ON-SITE SEWAGE DISPOSAL SYSTEM HOWARD COUNTY HEALTH DEPARTMENT BUREAU OF ENVIRONMENTAL HEALTH

P 526223

SUBDIVISION: Benedict Farm - Homewood Crossing LOT NUMBER: 20

ADDRESS: 11539 Fox River Drive PROPERTY OWNER: Toll MD III, LP

HO-94-4165
NOT TO SCALE

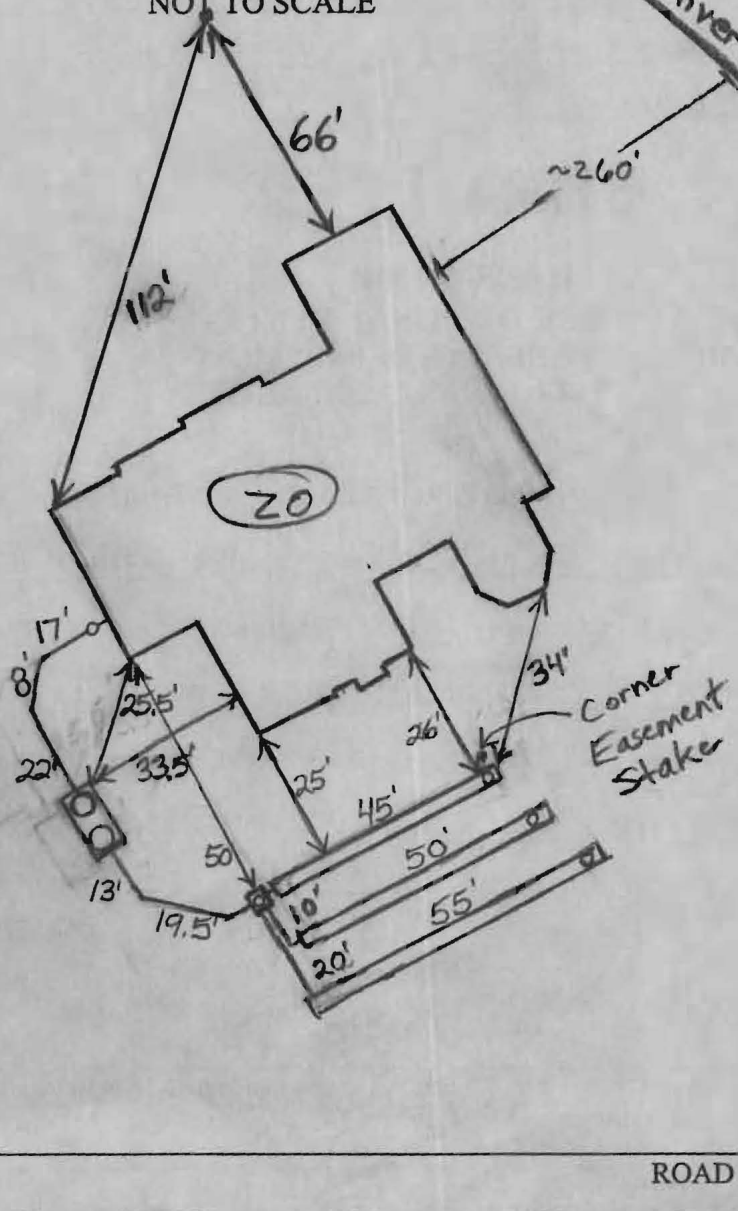
PRE-CONSTRUCTION 2/8/07 Set the distribution box near the top middle of the easement and install a 45, 50 and 55' trench
 INSTALLATION Towards the abandoned part of the septic area (PB)
 2/9/07 Tank set (PB) 2/12/07 Told installer to put levelers in distribution box. Everything else finished. O.K. to backfill. Easement stake at end of top trench, may be slightly mislocated.
 (PB)
